**World Forum for Harmonization of Vehicle Regulations**

Working Party on General Safety Provisions

**Regulation No. 46 (Devices for indirect vision)****Proposal for amendments to Regulation No. 46****Submitted by the expert from the United Kingdom of Great Britain and Northern Ireland\***

Figures 8c and 8d:

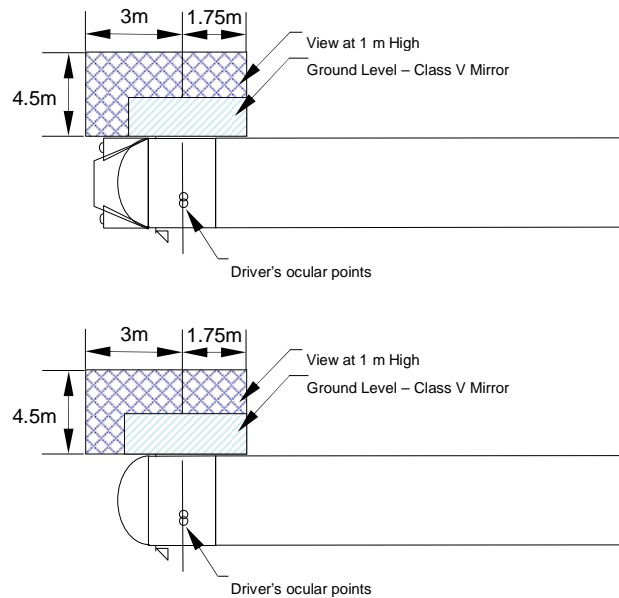
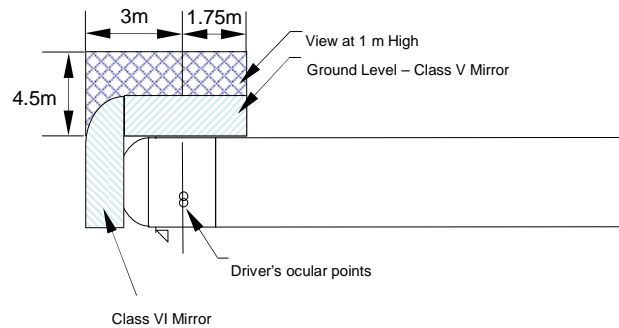
*Insert new paragraphs 15.2.4.5.6. to 15.2.4.5.10. (including new Figures 8c, 8d and 8e), to read:*

- “15.2.4.5.6. on the passenger side only, the field of vision shall also be such that the driver can see [part of] an object 1m high and 30cm in diameter which is outside the field defined in 15.2.4.5.1. to 15.2.4.5.4. but within the field bounded by the following vertical planes (see Figures 8c and 8d):

- 15.2.4.5.7. in the transverse direction, the parallel plane passing at a distance of 4.5 m in front of the plane mentioned in paragraph 15.2.4.5.1.
- 15.2.4.5.8. to the rear, the plane parallel to the vertical plane passing through the driver's ocular points and situated at a distance of 1.75 m behind that plane.

- 15.2.4.5.9. to the front, the plane parallel to the vertical plane passing through the driver's ocular points and situated at a distance of 3 m in front of that plane. This field of vision may be partially provided by a front mirror (see figure 8e).

- 15.2.4.5.10. In cases where the described field of vision prescribed in paragraphs 15.2.4.5.6. to 15.2.4.5.9. can be obtained without the use of devices for indirect vision then, in relation to these paragraphs, the installation of such devices is not required.
